UNITED STATES PATENT AND TRADEMARK OFFICE

APPLICATION NO.	FILING DATE	FIRST NAMED INVENTOR	ATTORNEY DOCKET NO.	CONFIRMATION NO.
08/936,510	09/24/1997	YONG BEOM KIM	8733.20056	9825
30827	7590	05/10/2004	EXAMINER	
MCKENNA LONG & ALDRIDGE LLP 1900 K STREET, NW WASHINGTON, DC 20006			CHOWDHURY, TARIFUR RASHID	
			ART UNIT	PAPER NUMBER
			2871

Office Action Summary	Application No.	Applicant(s) <i>AK</i>	
	08/936,510	KIM, YONG BEOM	
	Examiner	Art Unit	
	Tarifur R Chowdhury	2871

DETAILED ACTION

FIG. 1

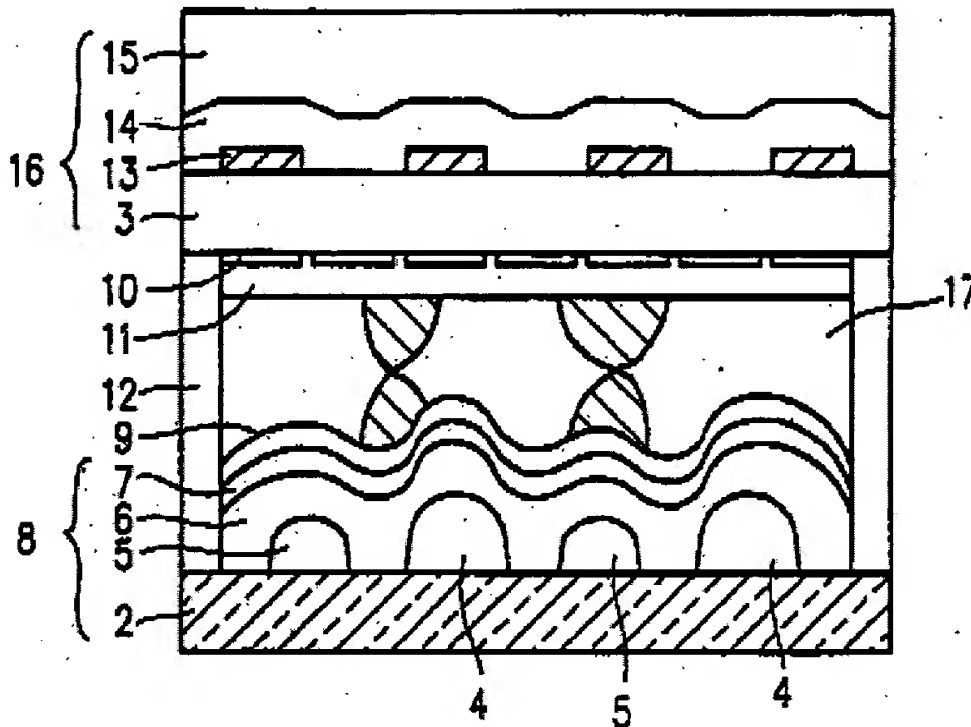
3. Mitsui discloses and shows in Fig. 1, a reflection-type liquid crystal display device, comprising:

- first (2) and second (3) substrates;
- a reflective electrode (7) over the first substrate (2), wherein the reflective electrode comprises metal such as aluminum, chromium etc. (applicant's opaque metal) (col. 5, lines 59-62);
- a liquid crystal layer (17) disposed interjacent the first and second substrates;
- two uniaxial optical compensation films (13,14) (col. 6, lines 11-13) of a same type (col. 10, lines 58-63; col. 12, lines 14-23) over the second substrate (3);
- and
- a first alignment layer (9) over the first substrate (2) (col. 6, lines 28-29).

Accordingly, claim 1 is anticipated.

As to claim 14, since the method of manufacturing the device is merely a list of forming each component and each component must be formed to make the device, the method of manufacturing would be inherent to the device.
